Arkansas State Highway and
Transportation Department

ROUTE SLIP

Date: 9-28-90

Remarks: After a Design and Maintenance Review in the field with District 10 personnel and discussion with Mr. Pinkerton, the attached changes will be made for future remodeling and regular jobs.

DETAILS FOR BLOCKING EXPANSION JOINT DEVICE

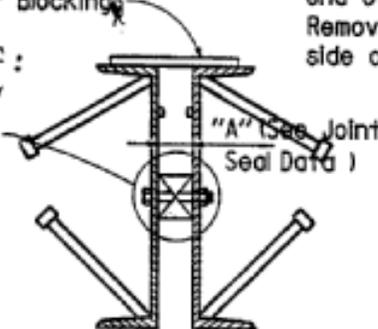
Change the DETAILS FOR BLOCKING
EXPANSION JOINT DEVICE on 14990H to:

One of two different blocking systems is required depending on the type of span finishing machine that is used.

For transverse strike-off:
Plate, Angle, or other shapes, attached to Channels (or Angles) for Blocking.

For longitudinal strike-off:
Bolt and spacer attached to channels for blocking.

Note: Blocking Detail shown for Joint at Int. Bent. Joint at End Bent is similar.
